Master Plan Amendment #2023-00001
Development Special Use Permit #2022-10021
Transportation Management Plan SUP#2023-00008

Montgomery Center
300, 312 & 320 Montgomery St.
805, 807 & 809 N. Royal St.
806 & 816 N. Fairfax St.

Staff Recommendation: APPROVAL WITH CONDITIONS**Staff Reviewers:**

Figure 9: Height increase proposal along Montgomery Street

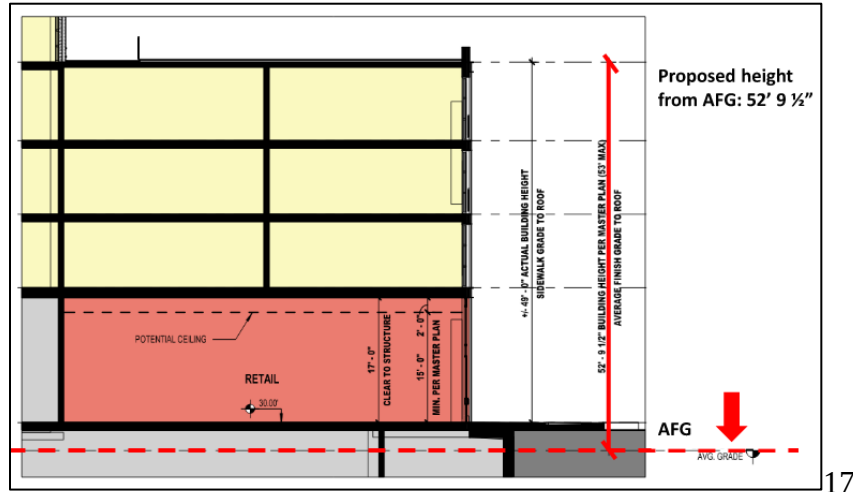
The applicant has requested a master plan amendment to the *Recommended Height District Limits* map (Figure 2.14 in the OTNSAP) to increase the height on the northern third of the site from 50 feet to 53 feet, in order to accommodate floor to ceiling height of 17 feet in the retail space on the first floor of the two, four-story building masses facing Montgomery Street. Building height is measured from average finished grade (AFG) and as a result of the seven-to-eight-foot grade change across the block, the Montgomery Street buildings are measured from an AFG approximately 3 feet 10 inches below grade (Figure 9). From AFG these two buildings facing Montgomery Street measure 53 feet 9.5 inches, but from the sidewalk the buildings will only rise to a height of 49 feet.

Staff has no objection to the proposed modest three-foot height increase in the 50 feet height zone for several reasons. First, the increased height is consistent with the OTNSAP Ground Floor Retail Use/Storefront Standard requiring a minimum floor-to-ceiling height of 15 feet, with a preference for 18 feet. Second, the ability to provide a clear height of 17 feet will help attract desirable tenants. Third, three additional feet will have limited impact on the public's perception of the building height, which will still be less than 50 feet from grade.

Figure 11: (1) N-S section through arts venue (2) E-W section through north building (3) E-W section through south building

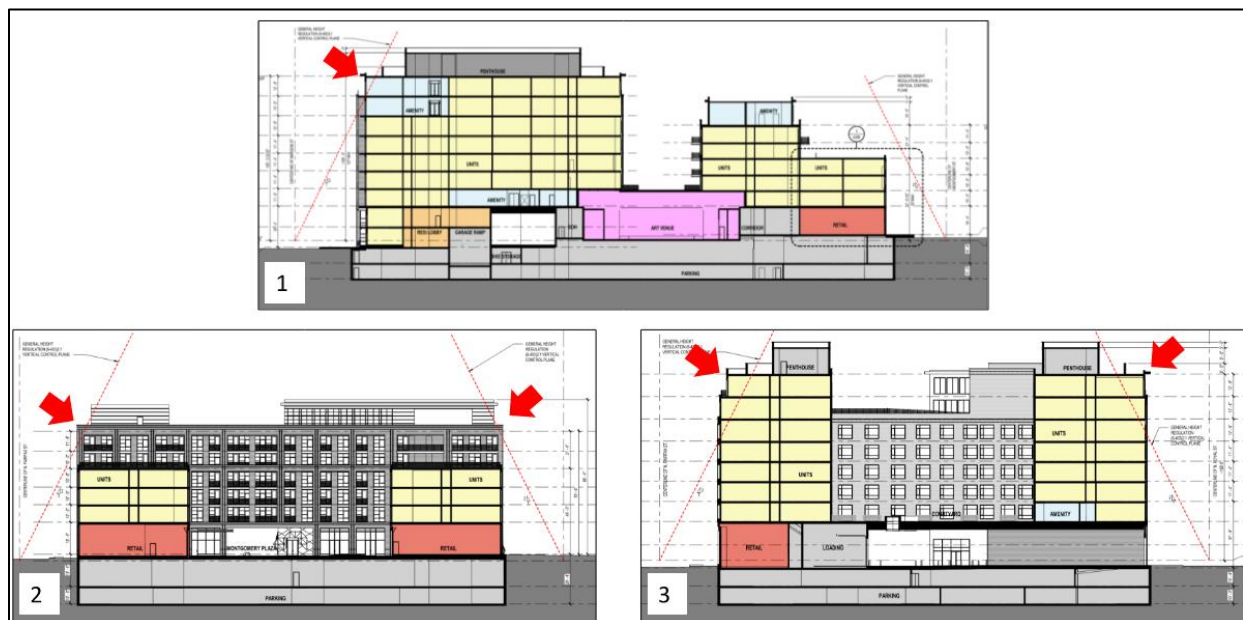
The applicant is requesting a modification to the height-to-setback ratio required by Section 6-403 of the Zoning Ordinance for minor portions of the upper floors as shown in Figure 11 below. The project design integrates varying heights, with the tallest portions on the southern two-thirds of the block as recommended in the OTNSAP. Portions of the building, particularly along Montgomery Street fall easily meet the height-to-setback ratio area.

1. The modification to the portions of the effected building are minimal in area and allow for a more desirable site and building layout. The central location of the arts venue and two plazas means that additional height is shifted to the south, as recommended in the OTNSAP.
2. The requested height-to-setback modifications does not adversely impact the surrounding blocks, particularly across Madison and N. Royal streets where a park and tall buildings are located. The building was designed to comply with the OTNSAP streetscape standards.
3. The modification request will not be detrimental to neighboring properties or to the public health, safety or welfare.

Figure 2.14: Recommended Height District Limits, as amended

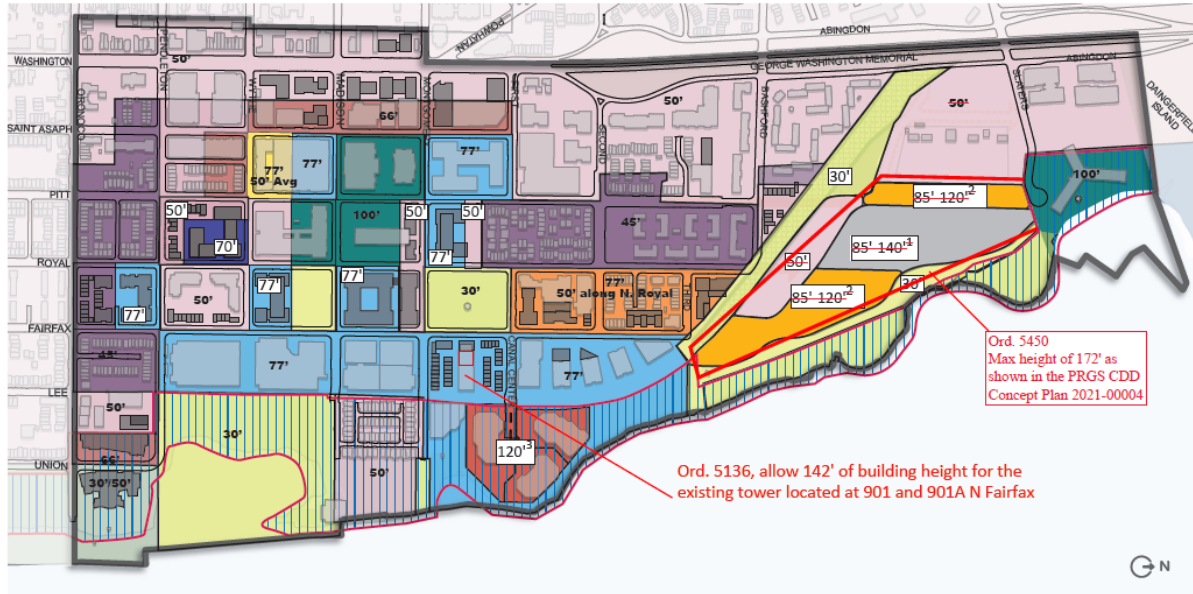
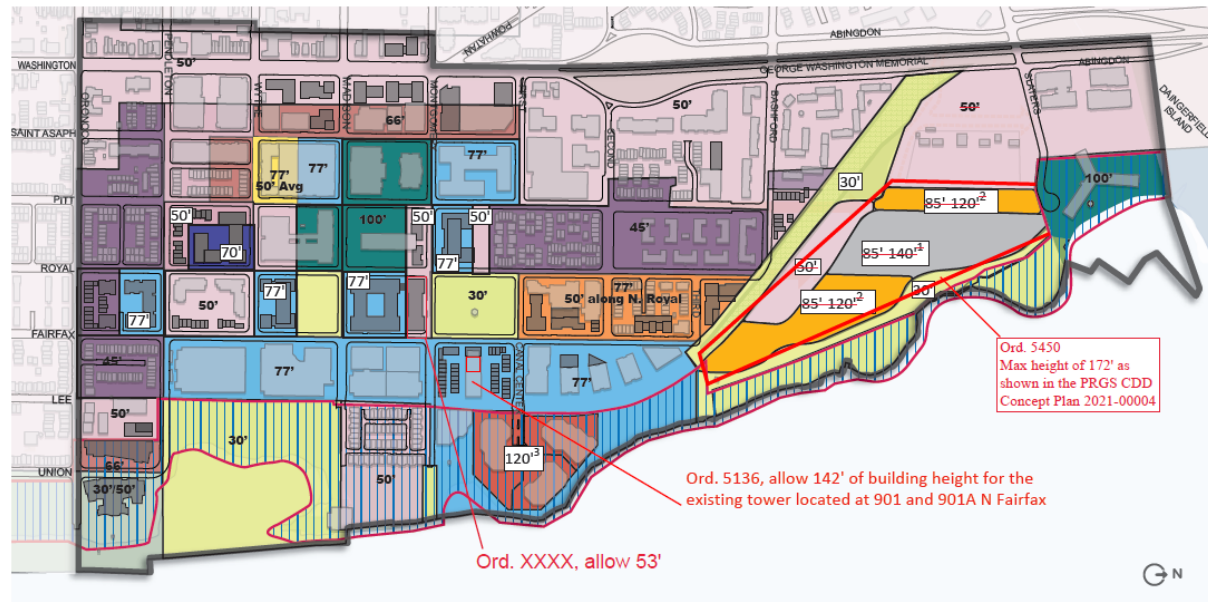
1. The attached amendments to the **Old Town North Small Area Plan** are hereby adopted in their entirety amending the Old Town North Small Area Plan chapter of the 1992 Master Plan of the City of Alexandria, Virginia in accordance with Section 9.05 of the Charter of the City of Alexandria, Virginia, to the:
 - Amend Figure 2.14: Recommended Height District Limits, to change the height limit for the east side of the property from 50 feet to 53 feet.
2. This resolution shall be signed by the Chairman of the Planning Commission and attested by its secretary, and a true copy of this resolution forwarded and certified to the City Council.
